Subject: RE: 375 Banfield Road CUP Application

Subject: RE: 375 Banfield Road CUP Application

COMMERCIAL SITE PLAN "INDUSTRIAL WAREHOUSE" TAX MAP 266, LOT 7 375 BANFIELD ROAD, PORTSMOUTH, NH

Plan Name:	GRADING AND DRAINAGE PLAN
Project:	INDUSTRIAL WAREHOUSE 375 BANFIELD ROAD, PORTSMOUTH, NH 03801
Owner of Record	BANFIELD REALTY LLC

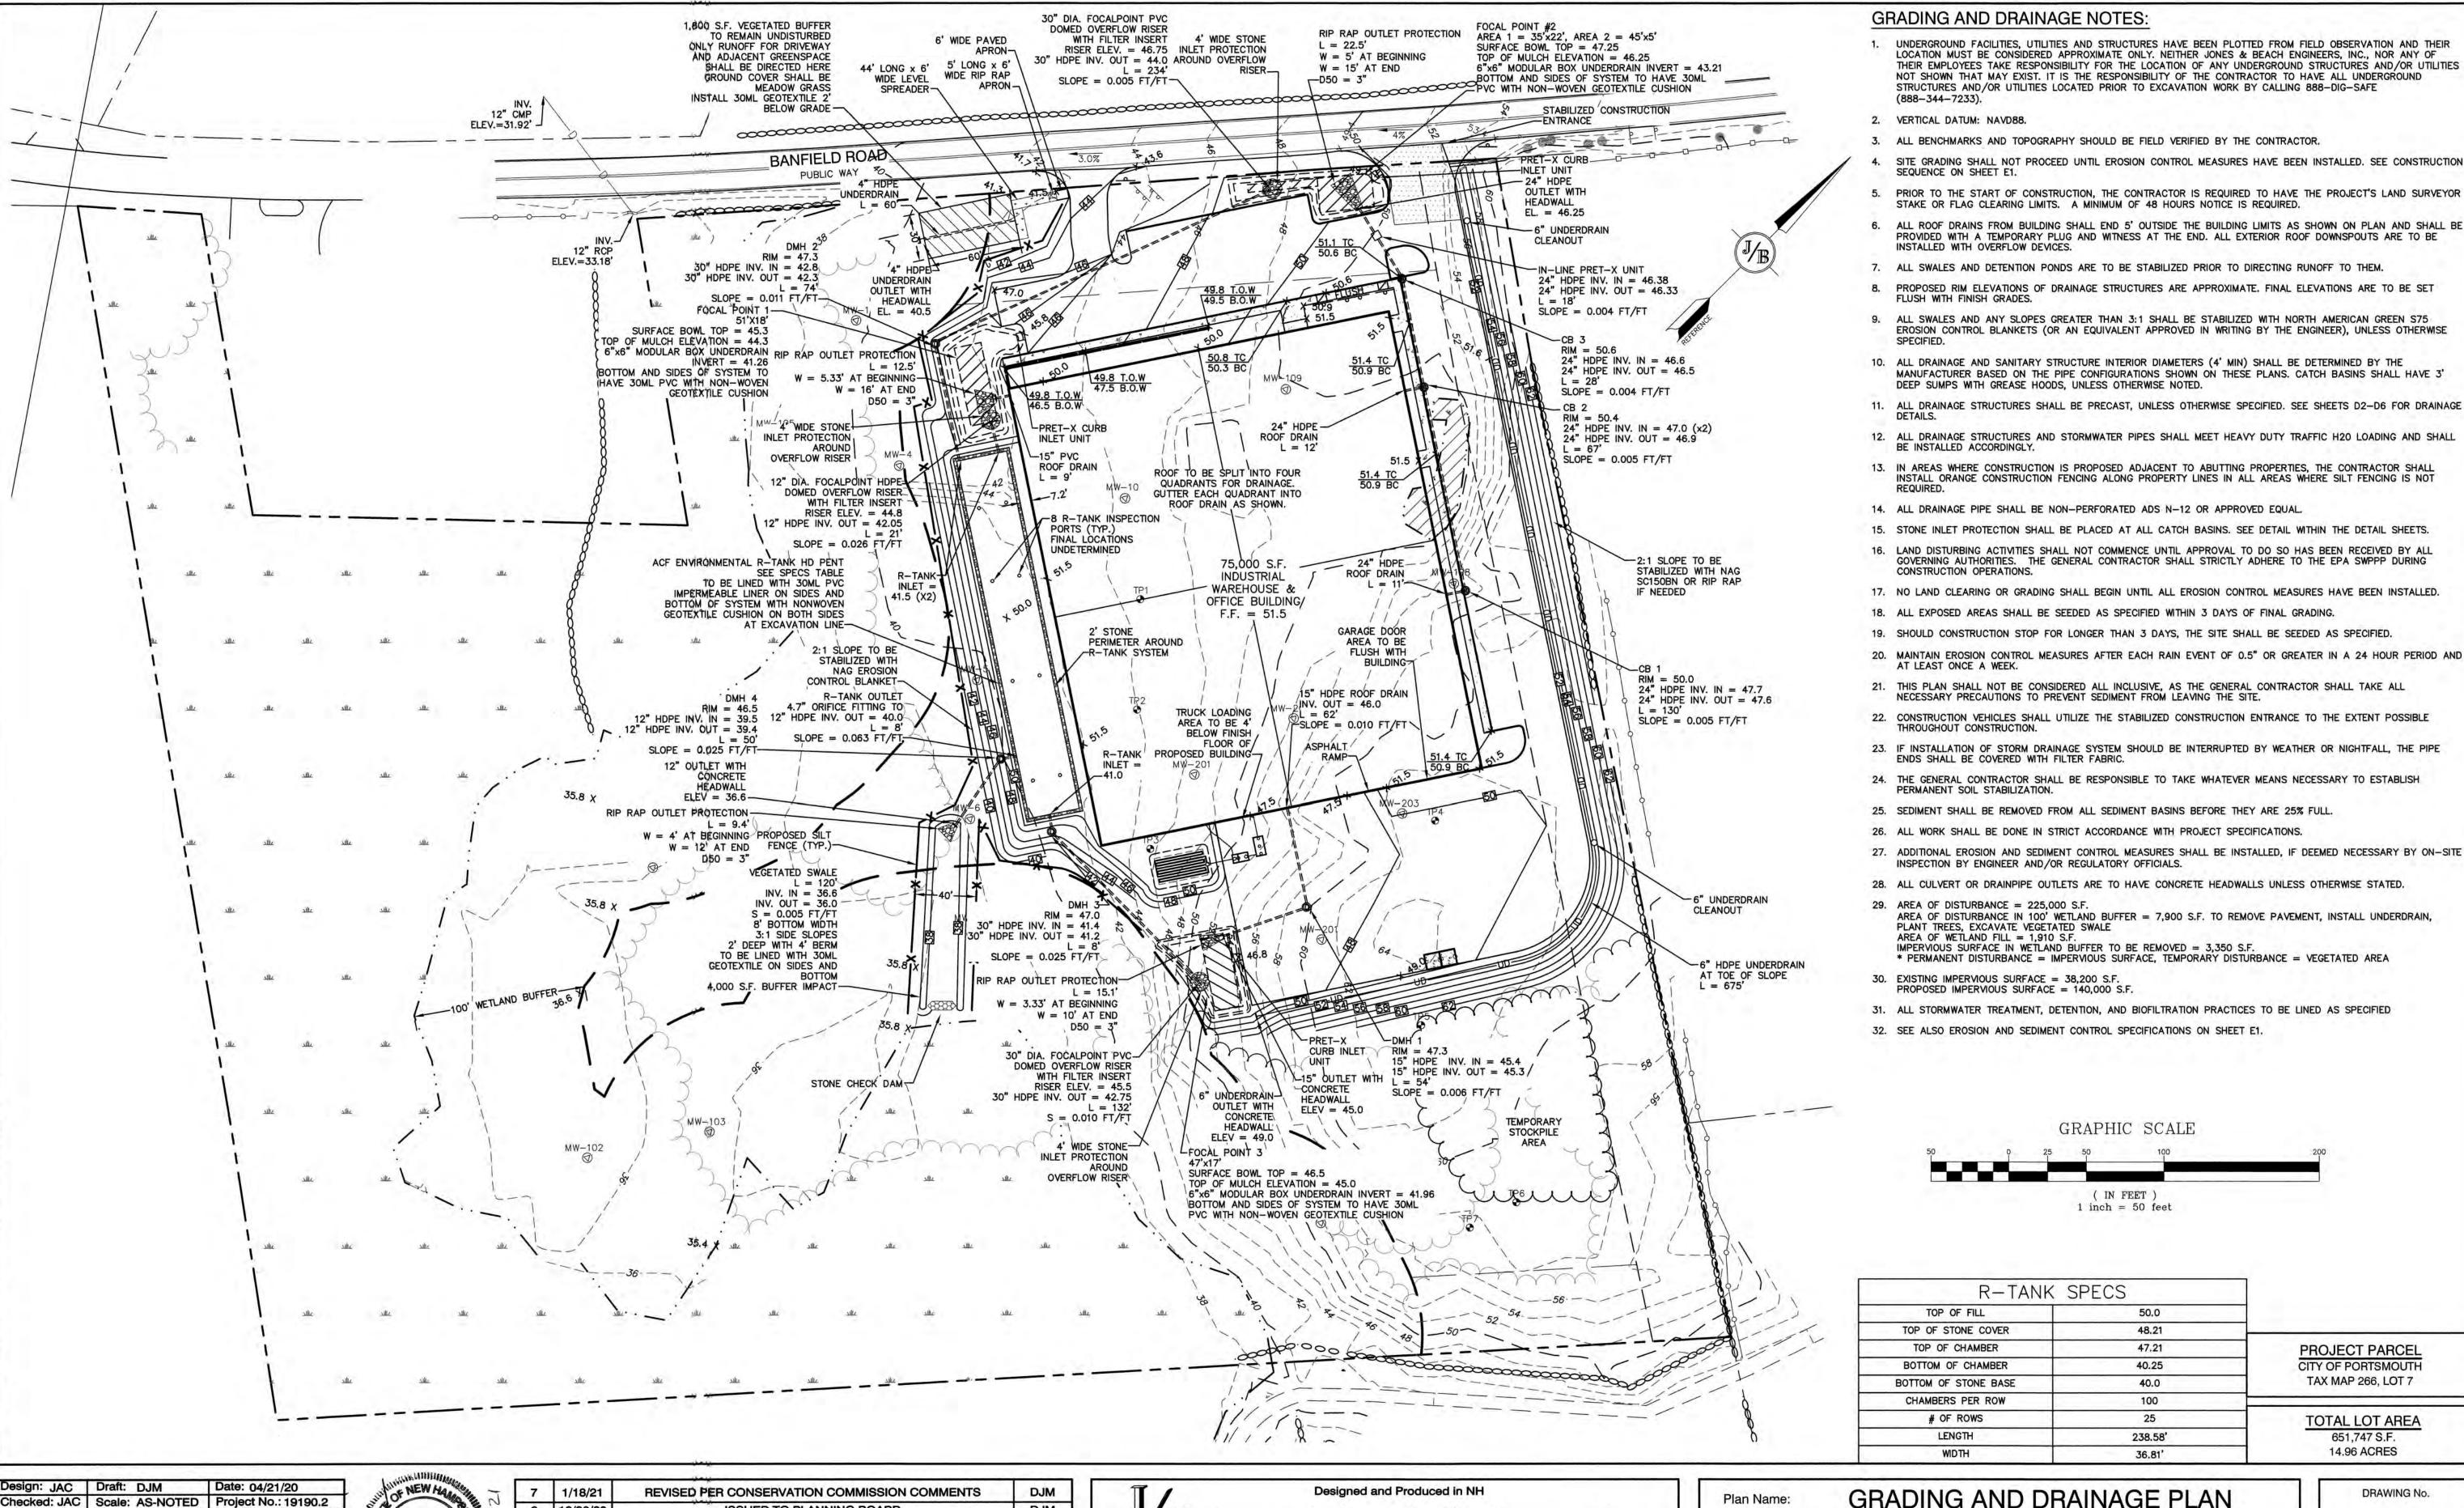
I am reviewing this new plan for the City's wetland CUP. Is there any analysis or justification for why this new impact needs to occur in the 100' buffer. I understand you could not put it where you wanted to at the last meeting and this seemed like a logical place. But is there any reason it could not be treated outside of the buffer so there is not impact? This is quite a large new impact in the buffer on a site that is essentially all new.

Yes, the justification is that we are not allowed to discharge stormwater over the existing solid waste fill that is on the property. The state is requiring that we bring any stormwater to the edge of the fill so we are discharging into the natural wetlands where there is no fill. The swale has to be lined so no water infiltrates as that is a restriction of the property due to the past use. That was the reason for the relocation and then if you recall we discussed targeting this location as it was the best spot per Jim Gove to discharge the stormwater for a multitude of reasons.

The impact is really not much of an impact either as this will be a vegetated swale that will grow in and not look much different than the existing meadow that is out there. We will see more of that on Monday during the sitewalk.
